GENERAL AVIATION ALLIANCE (GAA) RESPONSE TO LONDON OXFORD AIRPORT ACP CONSULTATION

This is the General Aviation Alliance (GAA) response to the London Oxford Airport (LOA) Airspace Change Proposal Consultation dated 15th December 2017 and should be read in addition to any responses from individual GAA member organisations.

Figure 1 – Position of VFR choke points

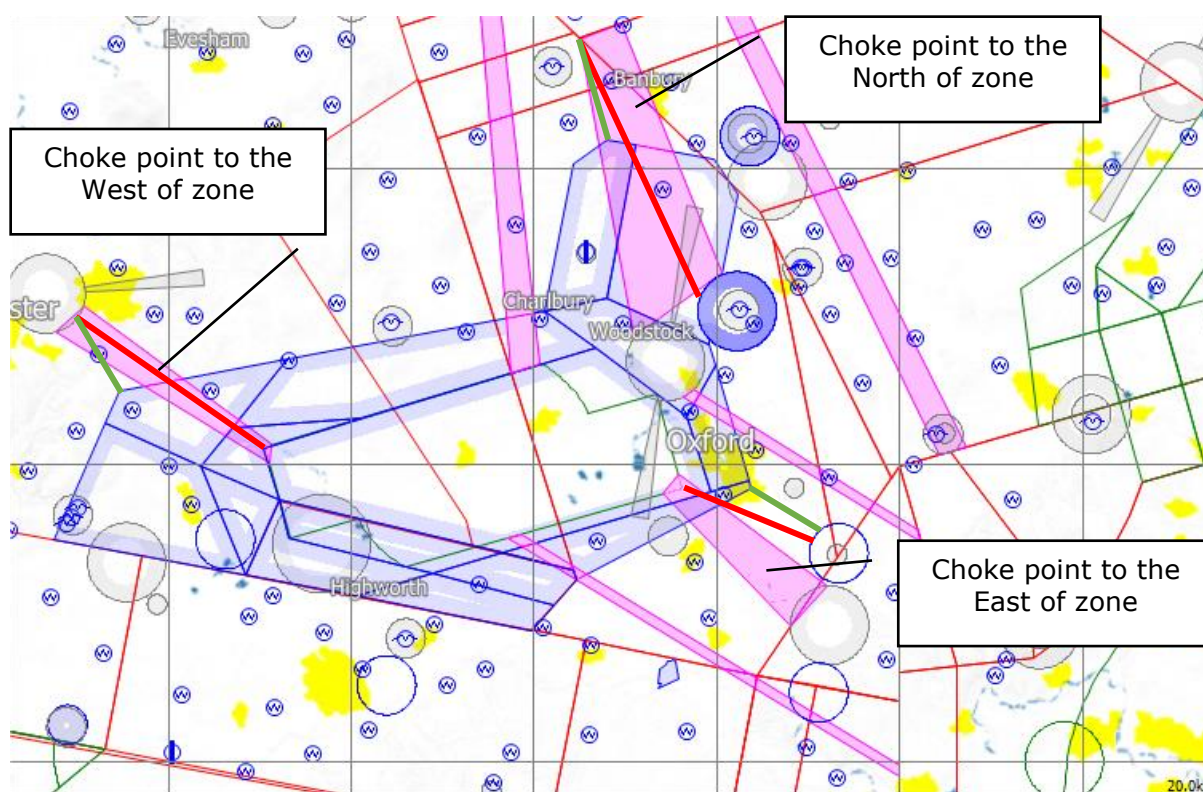
4.1.2 Choke points¹. Following on from the above, the sponsor has failed to properly evaluate the safety risk to GA at choke points where traffic density is likely to be increased as a result of the ACP. Extant GASCo advice to fly with no less than 2nm lateral and 200ft vertical separation from controlled airspace creates a further reduction in available airspace at such hot spots. The very real risks associated with choke points were highlighted by recent mid-air collisions near Wescott and between RAF Brize Norton and RAF Benson. In respect of the latter, Section 1.11.6 of AAIB Report 5/2010 showed that the level of GA activity in that area can be around 75 aircraft per hour and between 15-25 aircraft at any one time. This is a level which would probably exceed LOA’s ATC handling capability and we note that the sponsor makes no mention of enhancing that capacity to meet demand from GA traffic requesting crossing clearances through the proposed Class D airspace. Without

4.1.3 Increased collision risk. QinetiQ Report 10/02707 'Class G Airspace Modelling', to which the sponsor makes no reference, states '... the activity that takes places within Class G airspace is sufficiently well understood and predictable in its nature, such that the level of activity at any time can be calculated. More specifically, modelling can quantify the expected level of use and identify activity hotspots'. We have analysed present and proposed airspace widths and heights at known and projected choke points and have estimated the change in collision risk based upon guidance contained in AAIB Report 5/2010 if the majority of GA traffic elects (as is likely) to route around the proposed controlled airspace.

This analysis suggests that the risk of mid-air collision is roughly doubled at the south-eastern edge of the proposed airspace in the Brize Norton-Benson gap (East), and roughly trebled over the proposed Oxford CTR1 (North) and in the area around Kemble (West). Wholesale adoption by VFR traffic of extant GASCo recommendations regarding proximity from controlled airspace could see these risk levels elevated by an order of magnitude. Overall, we believe that the sponsor's decision not to conduct a meaningful analysis of either the LOA ATC capacity or the collision risk at GA choke points has wilfully misled the reader in respect of the level of risk that would be transferred to other airspace users, particularly GA.
